CNL-16-023

Browns Ferry Nuclear Plant, Units 1, 2, and 3  
Renewed Facility Operating License Nos. DPR-33, DPR-52, and DPR-68  
NRC Docket Nos. 50-259, 50-260, and 50-296

Subject: **Proposed Technical Specifications (TS) Change TS-505 - Request for License Amendments - Extended Power Uprate (EPU) - Supplement 4, Responses to Requests for Additional Information**

**Responses to NRC Requests for Additional Information  
EEEEB-RAI 2, EEEB-RAI 3, EEEB-RAI 4, and ESGB-RAI 1**

**Figure 1**  
**Coupon Test Assembly**

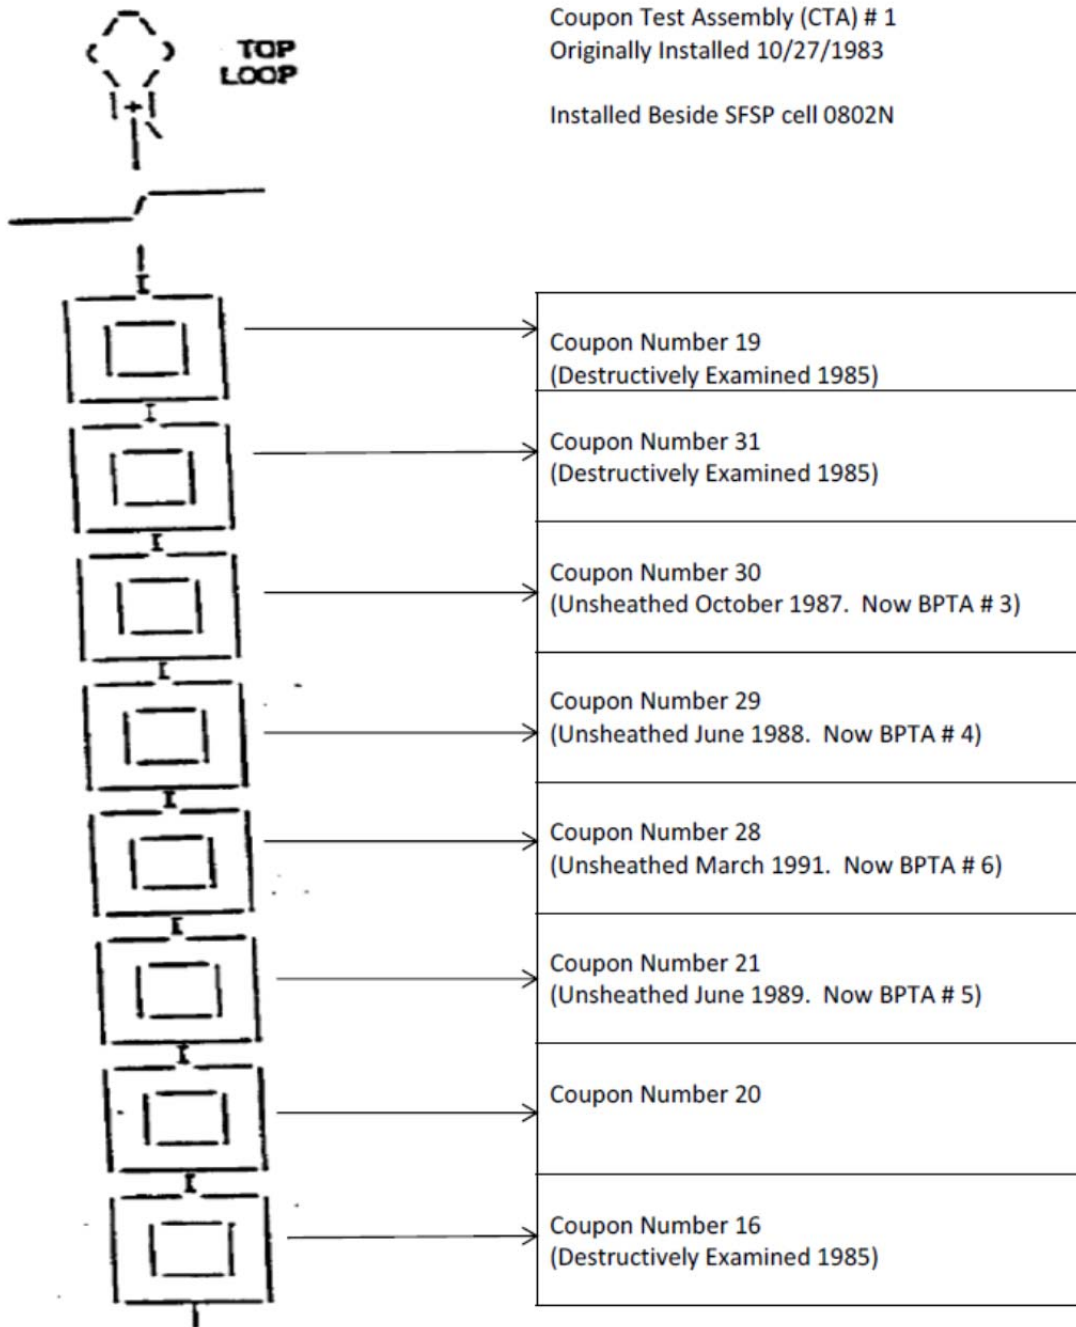
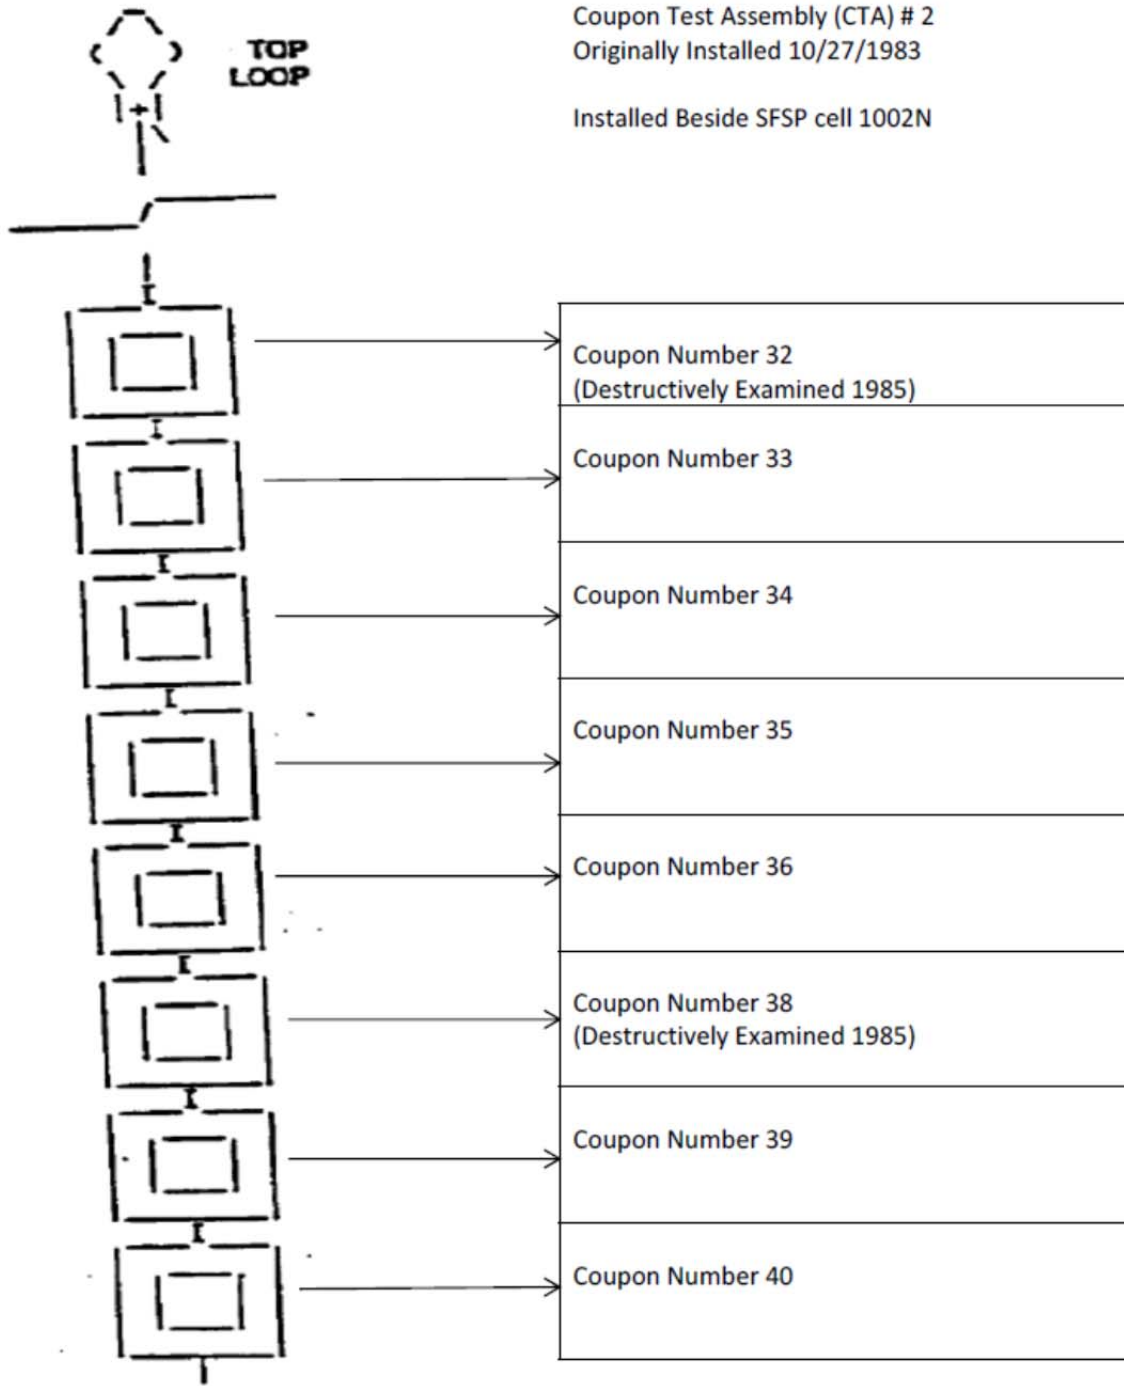
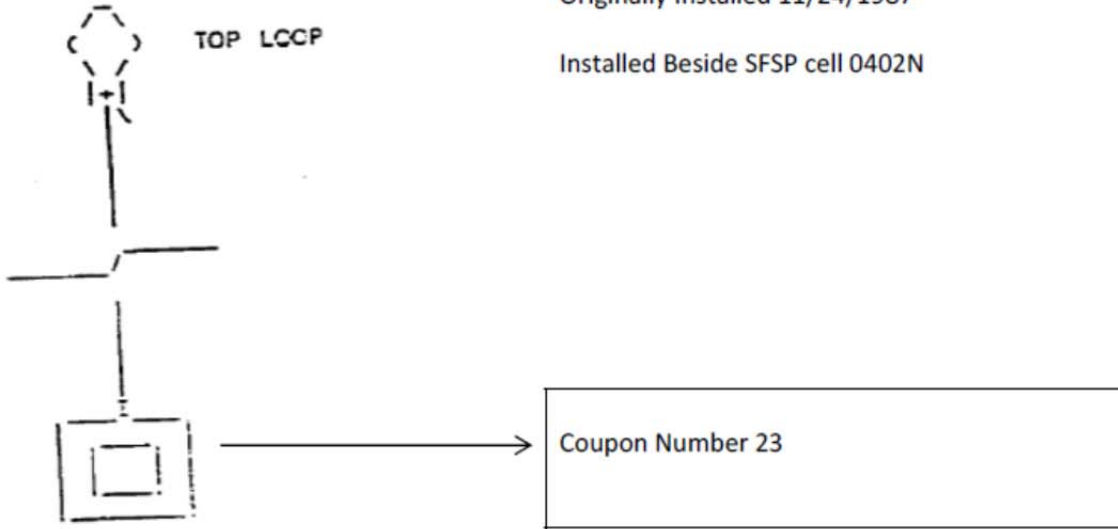
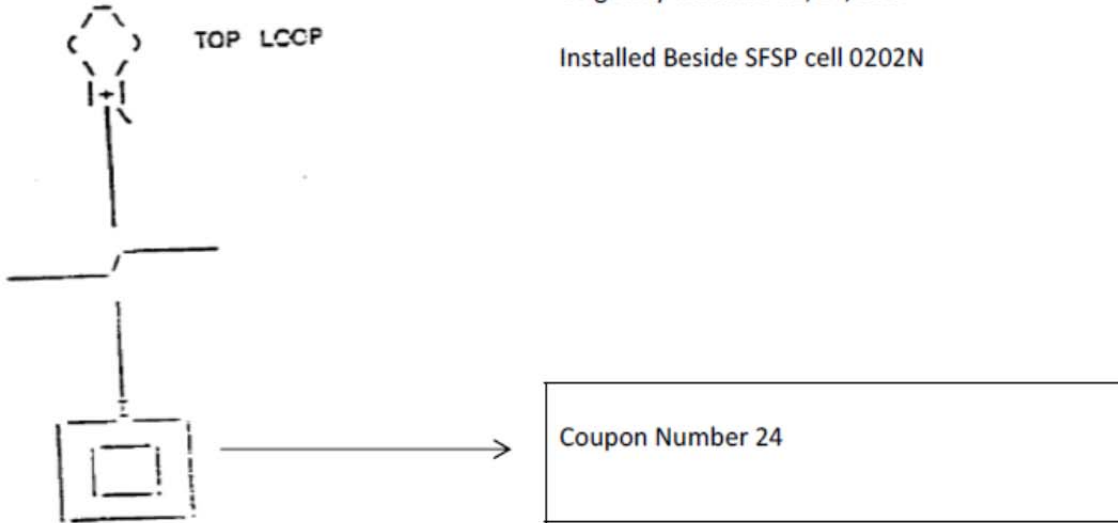
*In Section 10.3.6 of the Updated Final Safety Analysis Report, and in information provided in the supplemental letter dated December 15, 2015, it is indicated that a Boral neutron absorber monitoring program is used at BFN, Units 1, 2, and 3. The intent of the monitoring program is to manage potential reduction of neutron-absorbing capacity and loss of material due to general corrosion. However, in the sources mentioned, there is minimal information describing the Boral monitoring program. For this reason, please provide a brief description of the monitoring program. The information provided should include the following discussion:*

- A. *If test specimens (i.e., coupons) are used:*
  - i. *Define the periodicity for evaluation.*
  - ii. *Provide the number of coupons available.*
  - iii. *Describe any adverse conditions identified from coupon evaluation thus far.*

- iv. *Discuss the ambient conditions for the coupons in the spent fuel pool (e.g., surrounded by freshly discharged spent fuel assemblies).*
  - v. *Discuss whether coupons are returned to the spent fuel pool after inspection.*

BFN currently has nine Boral Cermet test coupons resident in the Unit 3 SFSP. These nine coupons are installed in four CTAs as shown in Figure 1. BFN currently has six BPTAs resident in the Unit 3 SFSP as shown in Figure 2. BPTA #1 (coupon number 22) and BPTA #2 (coupon number 41) were installed as new test assemblies in the Unit 3 SFSP on November 24, 1987 at the end of the October 1987 coupon inspection surveillance. BPTA #3 (coupon number 30) was unsheathed during the October 1987 coupon inspection surveillance and was re-inserted into the Unit 3 SFSP on November 24, 1987. BPTA #4 (coupon number 29) was unsheathed during the June 1988 coupon inspection surveillance and was re-inserted into the Unit 3 SFSP on July 20, 1988. BPTA #5 (coupon number 21) was unsheathed during the June 1989 coupon inspection surveillance and was re-inserted into the Unit 3 SFSP on June 30, 1989. BPTA #6 (coupon number 28) was unsheathed during the March 1991 coupon inspection surveillance and was re-inserted into the Unit 3 SFSP on April 9, 1991 (Response to RAI item A.ii of RAI). Figure 3 illustrates how the test coupons at BFN are hung from the side of the Unit 3 SFSP to be in proximity to the HDFSRs. (Partial response to Item A.iv of the RAI).

In October 1983, a total of 16 Boral Cermet test coupons were installed in the Unit 3 SFSP. The 16 coupons were contained in two CTAs (CTA #1 and CTA #2) as shown in Figure 1. The test coupons were supplied by the HDFSR manufacturer and are of the same metallurgical condition as the HDFSR in thickness, chemistry, finish and temper. Each test coupon had a hole drilled through the stainless steel sheath covering the Boral Cermet, which allows exposure of the Boral

In October 1985, two surveillance coupons, identified as coupons #19 and #31 (See Figure 1) were withdrawn from the Unit 3 SFSP per the BFN test procedure (ST-8322). The coupons had fixed contamination and were shipped to a hot cell for examination. Dye penetrant testing was performed on the stainless steel sheath of each coupon with no anomalies reported. Thickness measurements were performed and comparisons to pre-exposure measurements indicated some slight deformation of the stainless steel sheath.

Because three different Boral lots existed in the 16 coupons in the BFN SFSP, one coupon from each lot was retrieved for testing. These three coupons, identified as #16, #32 and #38 (See Figure 1) along with the originally removed #19 and #31 coupons were shipped to the University of Michigan (U of M) Phoenix Memorial Laboratory. Thickness measurements were taken at the pre-characterization locations on each coupon stainless steel sheath. Coupon #16 exhibited a slight increase between the pre-exposure and post-exposure measurements.
